ISSUE FOR SSD2 MOD 1

TWEED VALLEY HOSPITAL

PROPOSED SITE PLAN

Areas highlighted below are proposed to be updated as per the report and drawings within this modification. Page 1 (STB-AR-SKE-PRW-1000015) of this Appendix provides commentary on the areas highlighted

GENERAL ARRANGEMENT PLAN  
GROUND

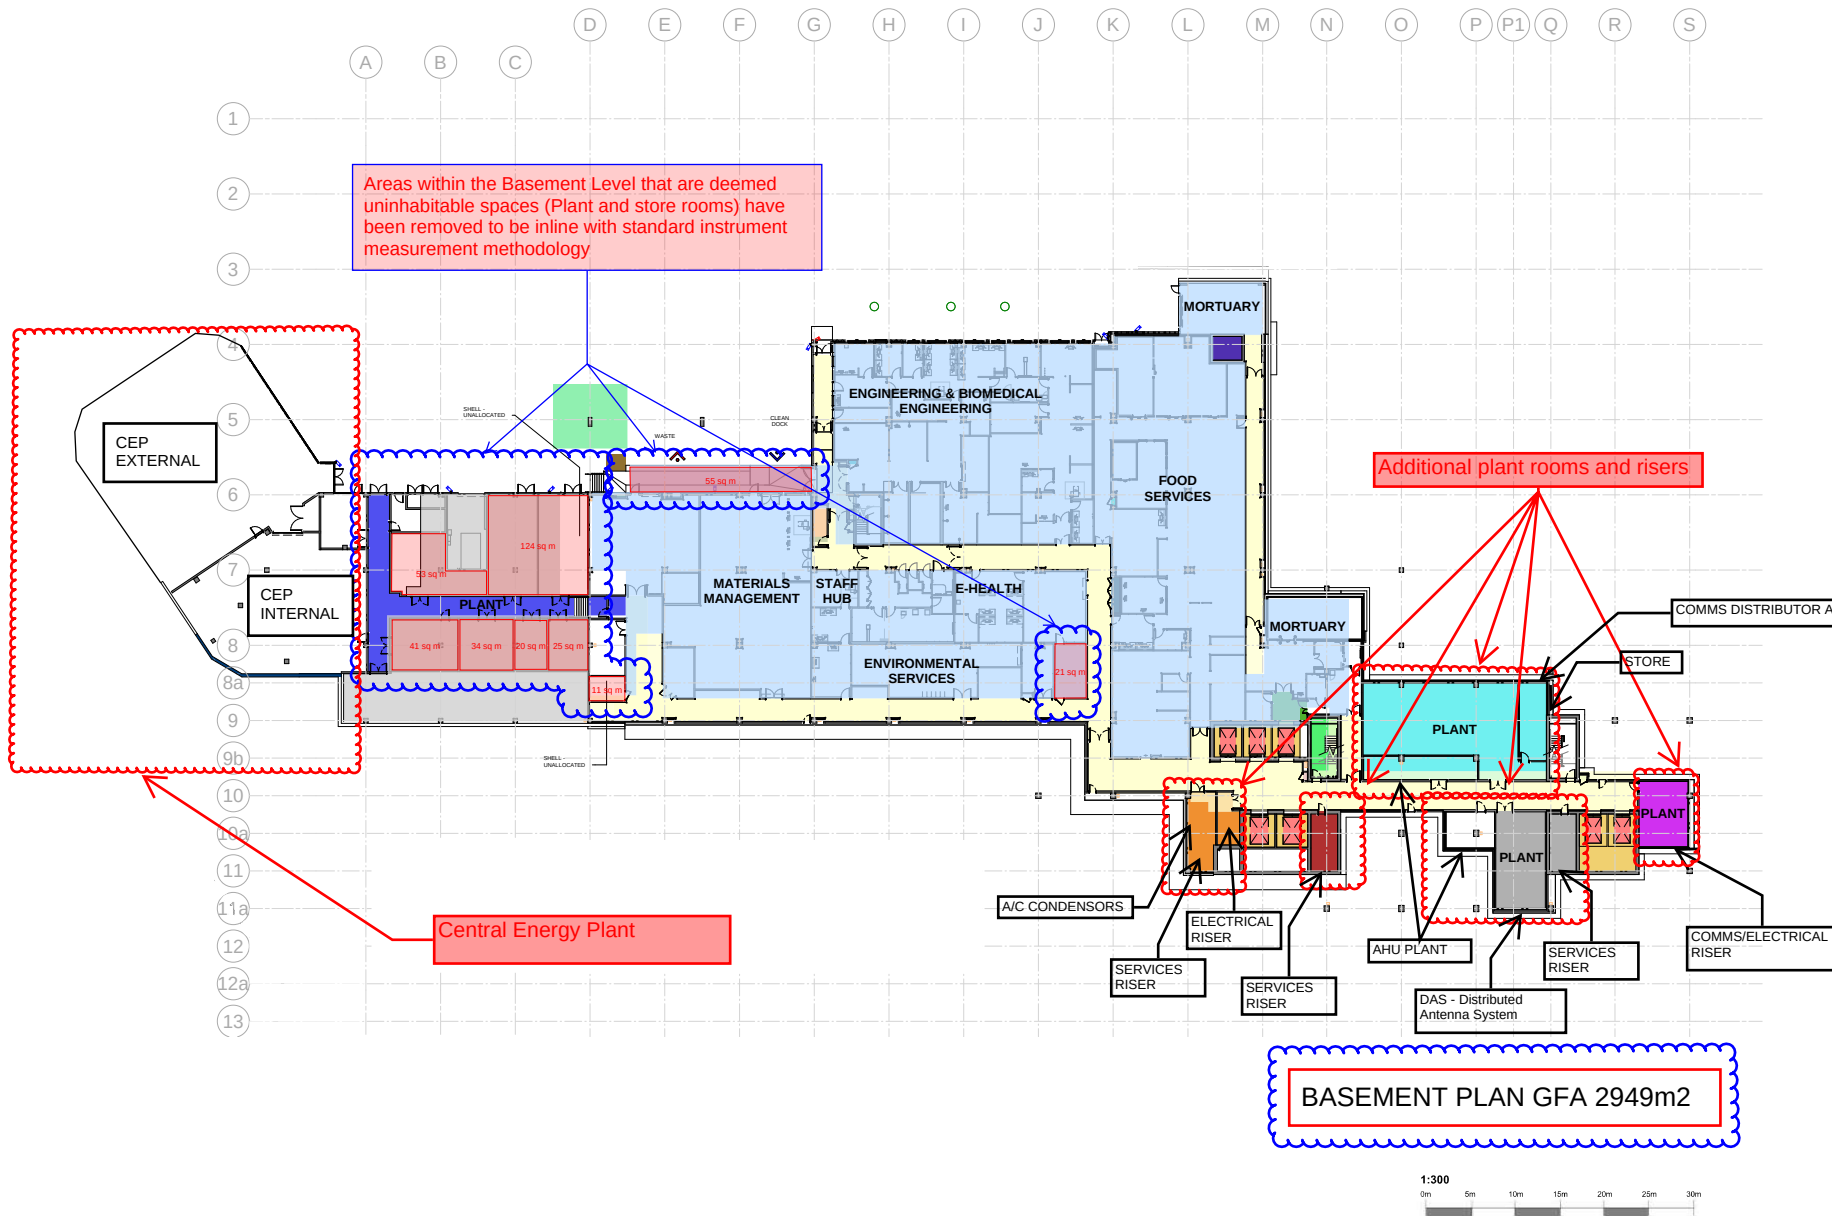
Ground Level GFA clarification - July 2021  
(from 11,681 to 11,919 m2 total)

PET SUITE & NW CORNER  
PLANTROOM  
EXTENDED

RADIOTHERAPY  
BUNKERS EXPANSION &  
CORRIDOR SHIFT SOUTH

RENAL DEPT CUT BACK AT  
GROUND LEVEL

GENERAL ARRANGEMENT PLAN  
LEVEL 01

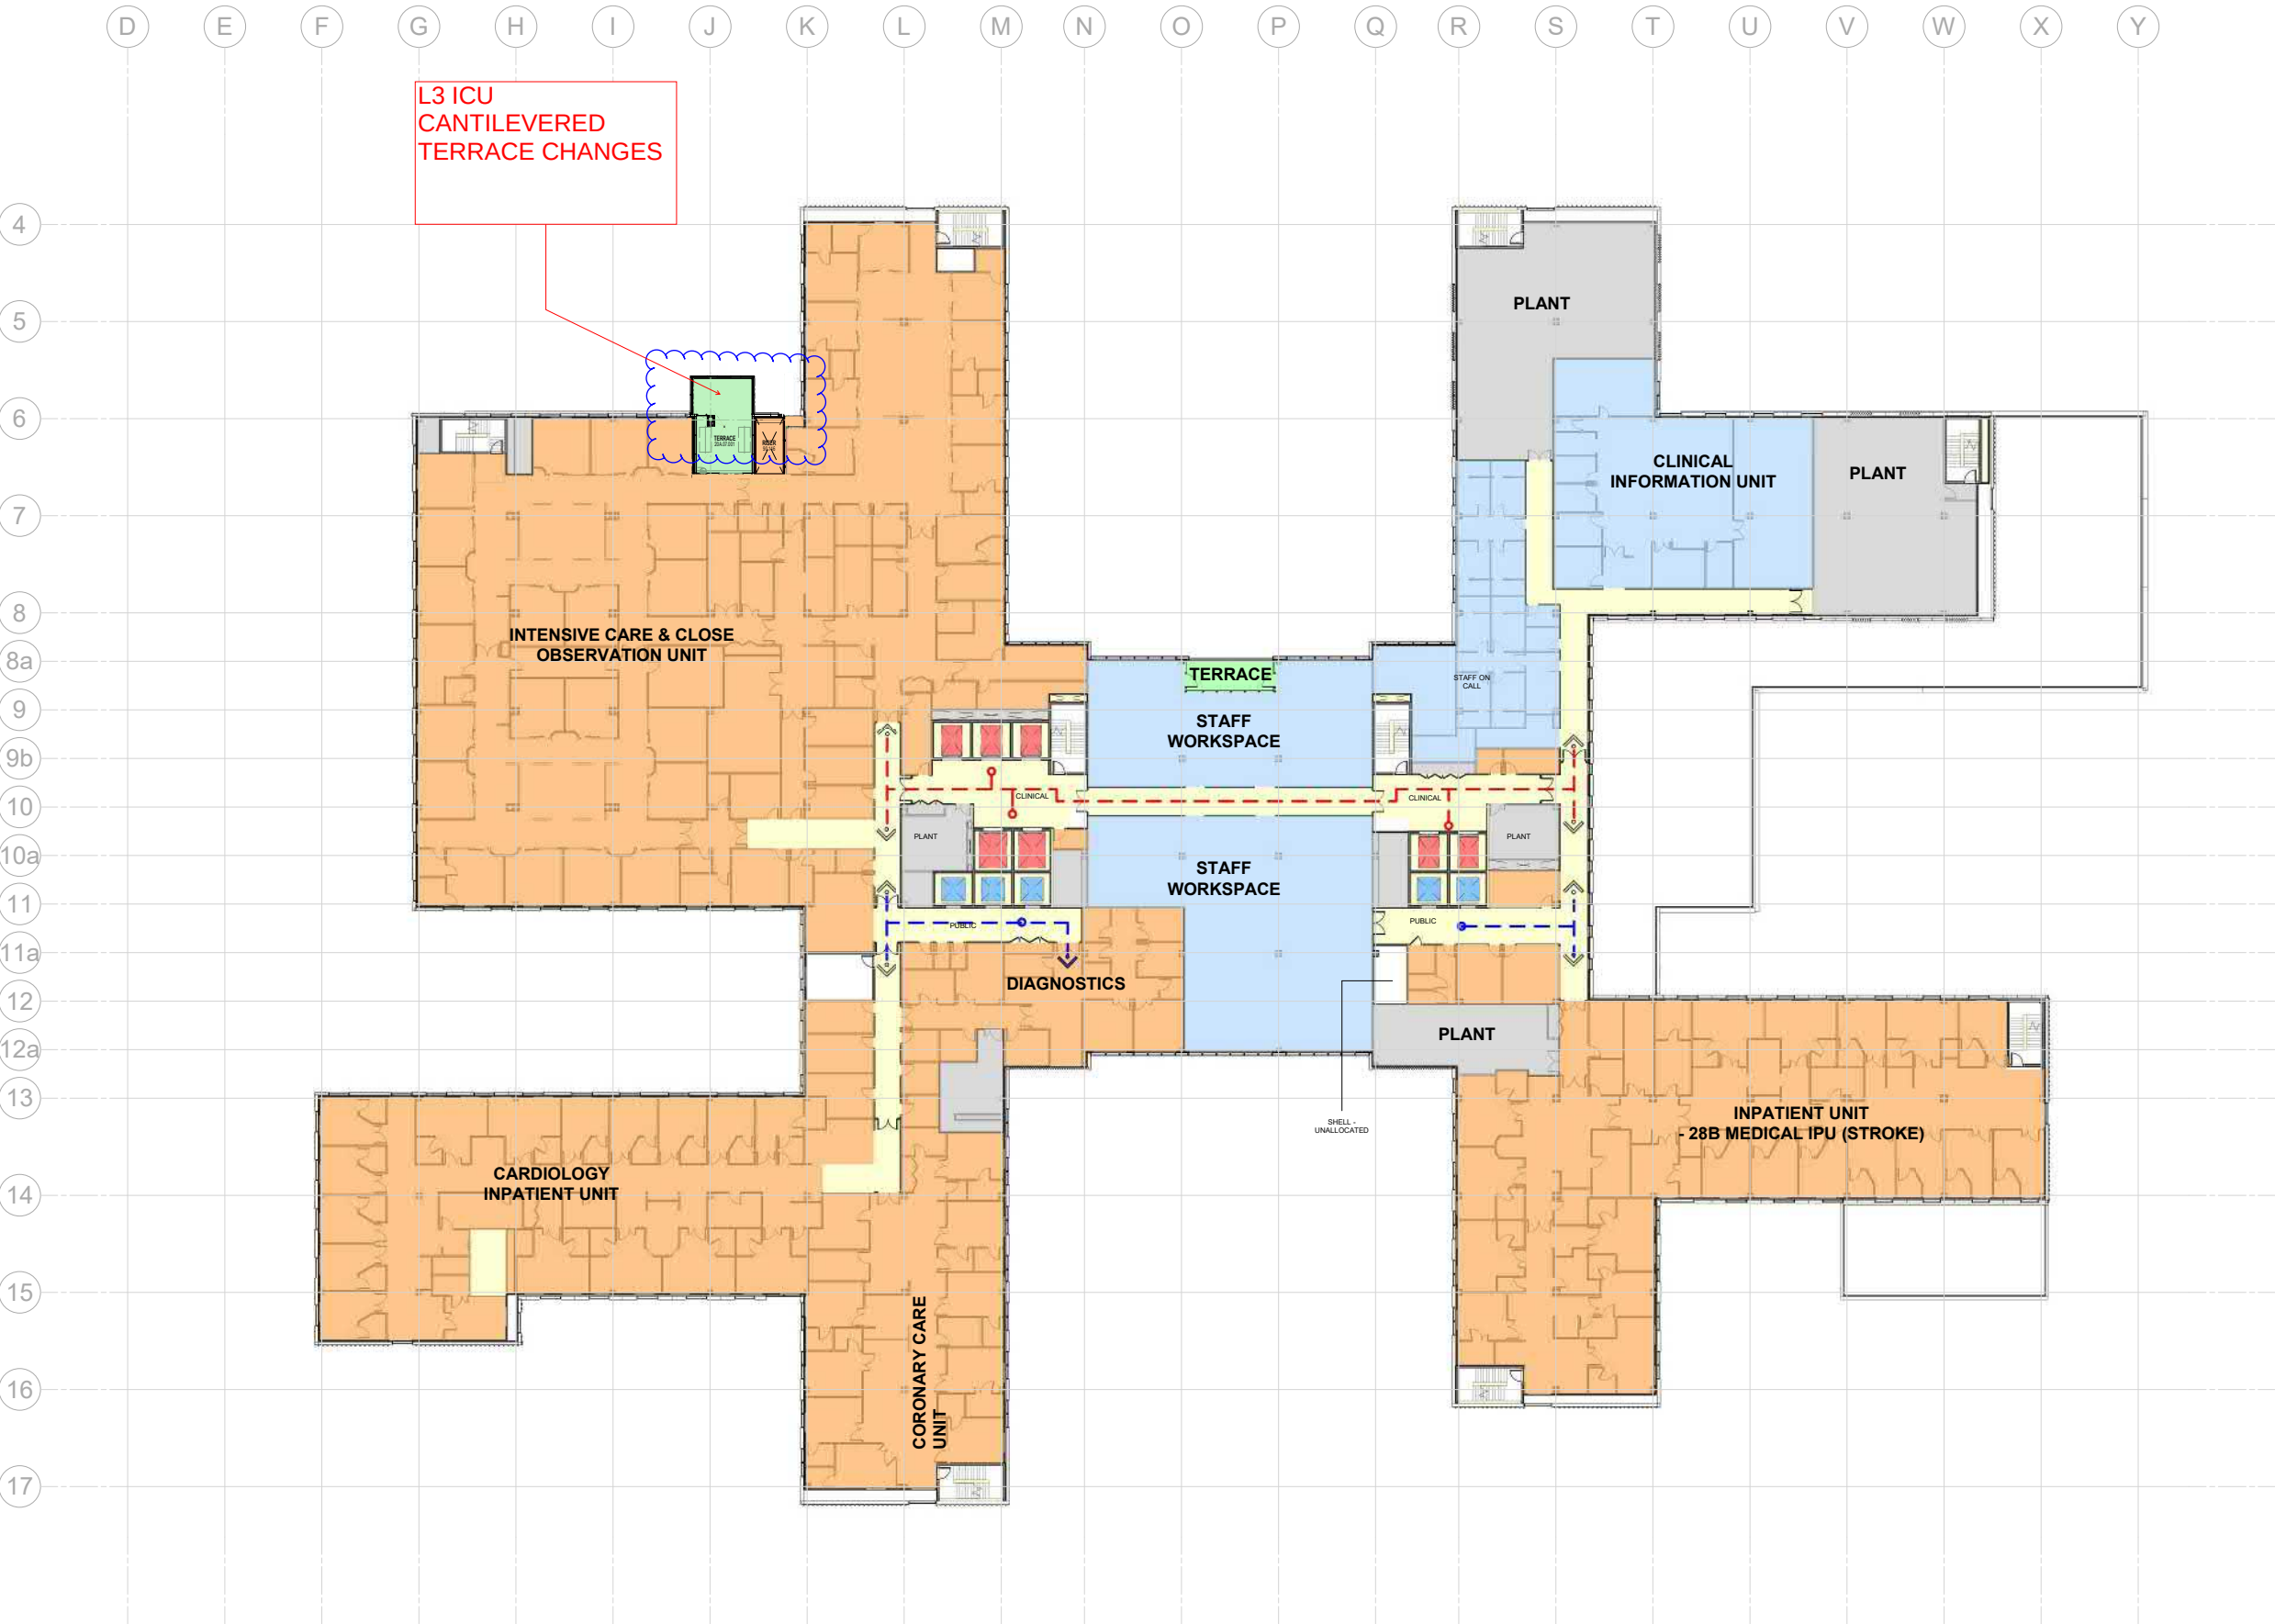
Level 1 GFA clarification - July 2021 (No change from 9,253 m2 total)

EXTENDED ROOF OVER PET SUITE & NW CORNER PLANTROOM

EXTENDED ROOF OVER RADIOTHERAPY BUNKERS EXPANSION & CORRIDOR SHIFT SOUTH

RENAL DEPT CUT BACK BELOW

KEY ELEVATIONS 3 & 4

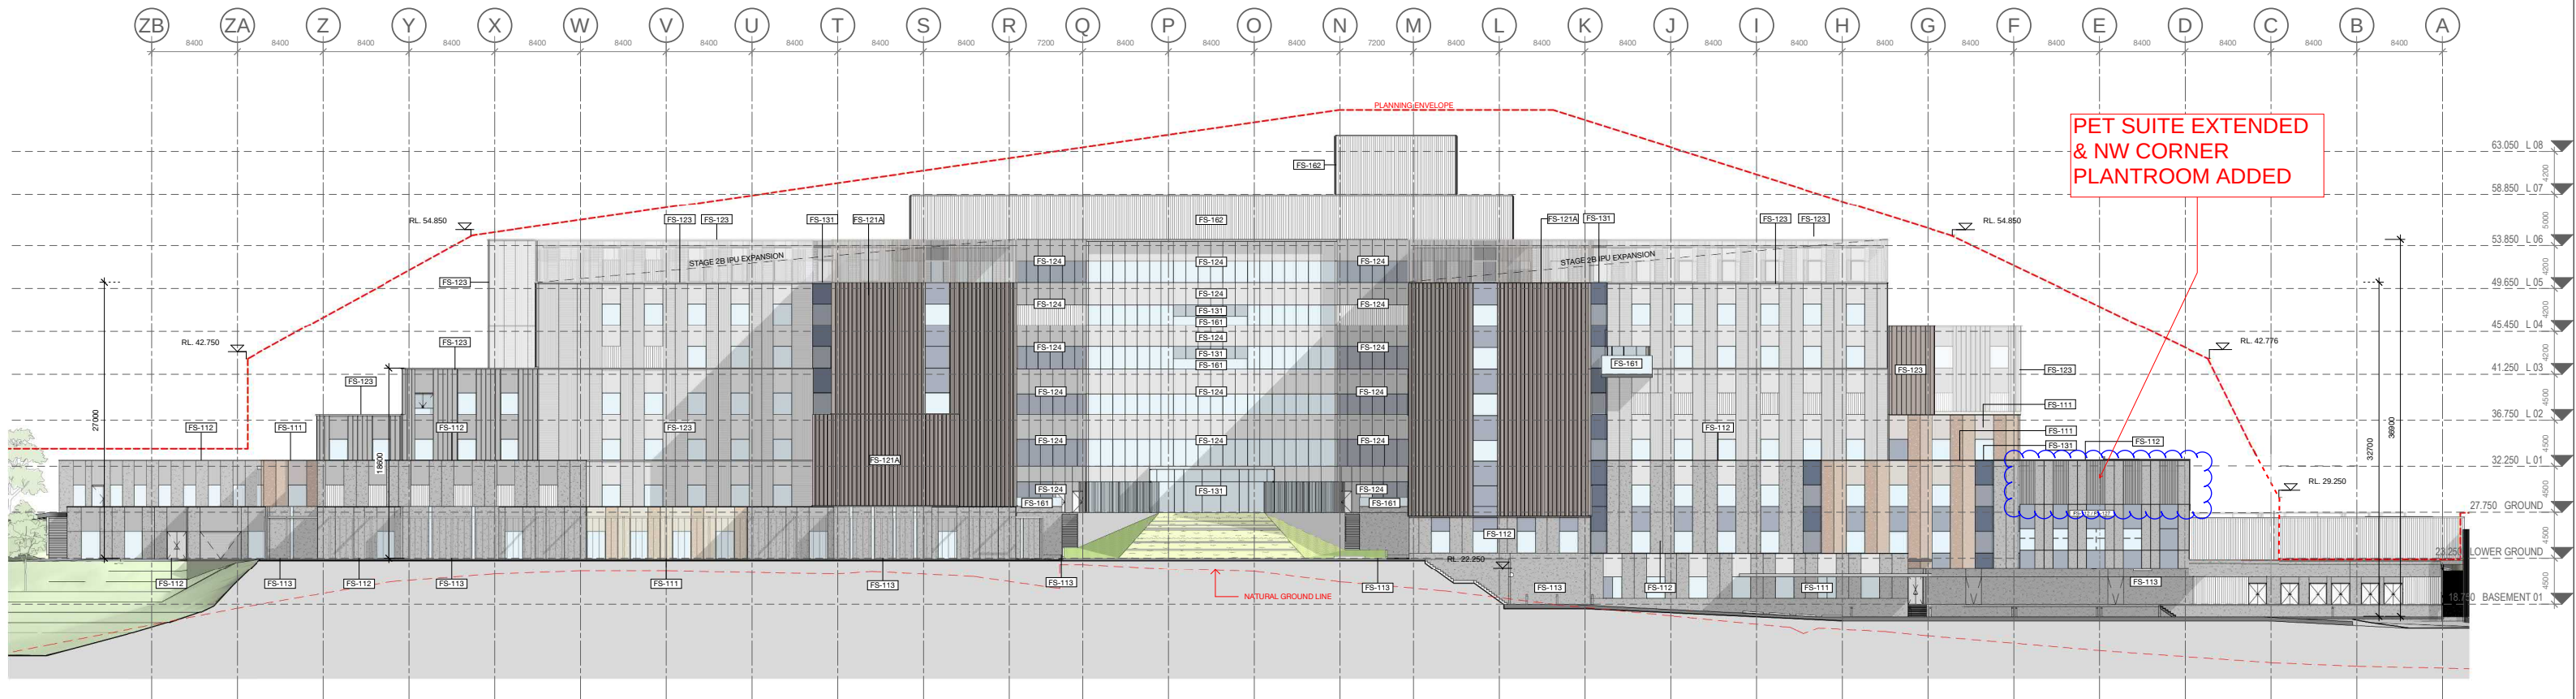
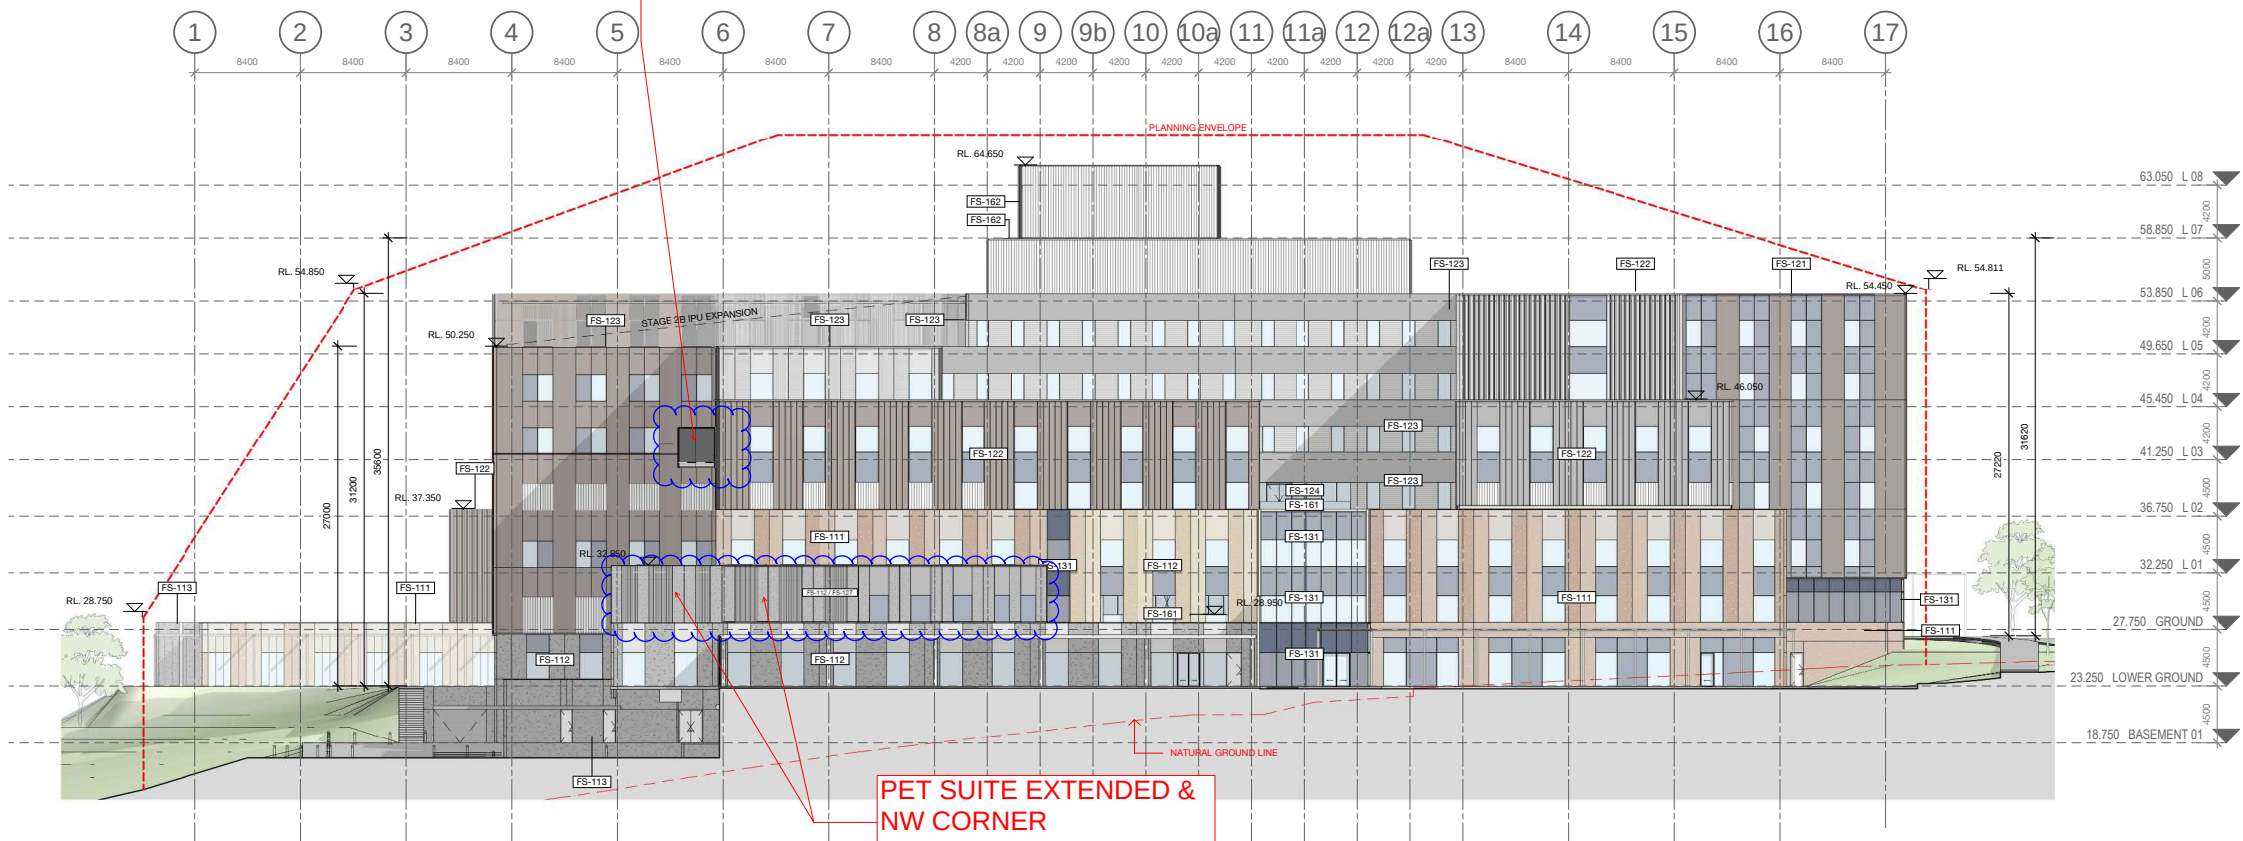
L3 ICU CANTILEVERED TERRACE CHANGES

PET SUITE EXTENDED & NW CORNER PLANTROOM ADDED
